Re: Response to Planning

SITE: Volunteer Inn, Walkers Green, Marden, HR1 3ET
TYPE: Outline
DESCRIPTION: Site for residential development (family housing) for up to 75 dwellings (comprising open market and affordable housing [including starter homes]), together with a new vehicular and pedestrian access, on-plot car parking, supporting infrastructure and facilities, amenity open space, landscaping and a sustainable urban drainage system.
APPLICATION NO: 163157/F
GRID REFERENCE: OS 352068, 248057
APPLICANT: S&A Produce (UK) Limited
AGENT: Aspbury Planning Limited

Envireau Water have produced a flood risk assessment and drainage strategy for the aforementioned planning application. This has been reviewed by WSP Parson Brinckerhoff (WSP) on behalf of Herefordshire County Council (HCC). WSP provided a review document (Appendix A) and made recommendations that further information is provided prior to the HCC granting planning permission for the development.

APPLICATION NO: 163157
GRID REFERENCE: OS 352068, 248057
APPLICANT: S&A Produce (UK) Limited
AGENT: Aspbury Planning Limited
DATE OF THIS RESPONSE: 04/11/2016

Figure 1: Environment Agency Flood Map for Planning (Rivers and Sea), October 2016

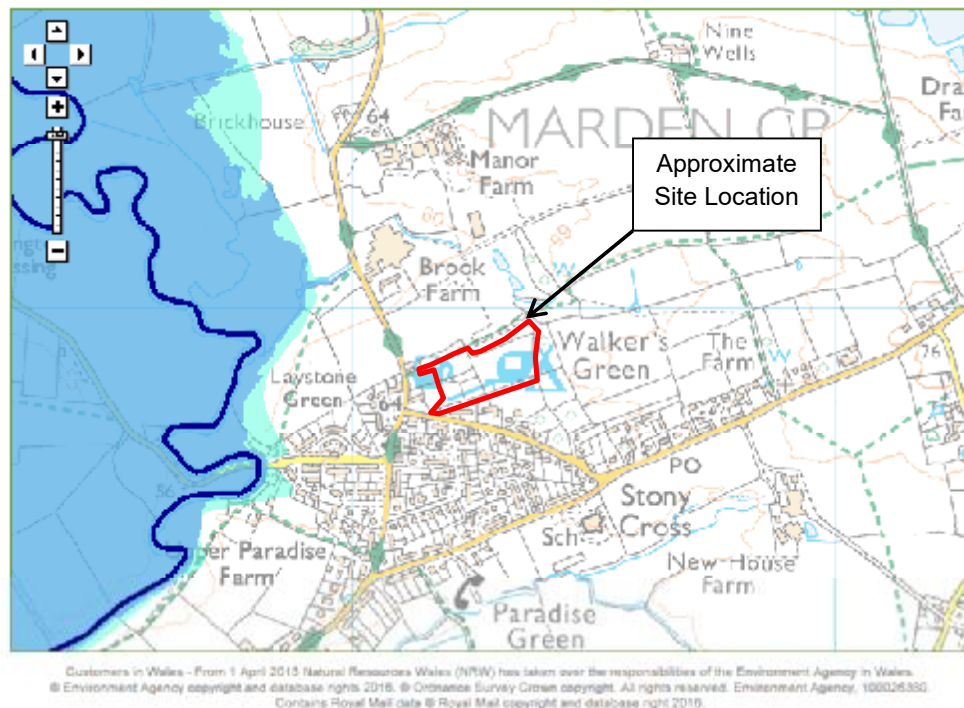
Review of the Environment Agency's Flood Map for Planning (Figure 1) indicates that the site is located within the low risk Flood Zone 1. Flood Zone 1 comprises land assessed as having less than a 1 in 1,000 annual probability of river flooding.
